TRANS/WP.1/2003/1/Rev.1
29 April 2003

**AMENDMENTS TO AND IMPLEMENTATION OF THE
1968 CONVENTIONS ON ROAD TRAFFIC AND ON
ROAD SIGNS AND SIGNALS AND THE 1971 EUROPEAN
AGREEMENTS SUPPLEMENTING THEM**

**Consolidated proposals for amendments to the
Vienna Convention on Road Traffic**

MODEL 3
Right hand page

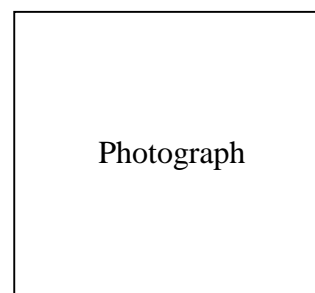
Replace the left and right hand pages of model No. 3 by the following:

The amendment proposed is intended to replace the existing model of the international permit in order to bring it into line with the provisions of Article 41, paragraph 2, and with the categories and subcategories of driving permits introduced in Annex 6.
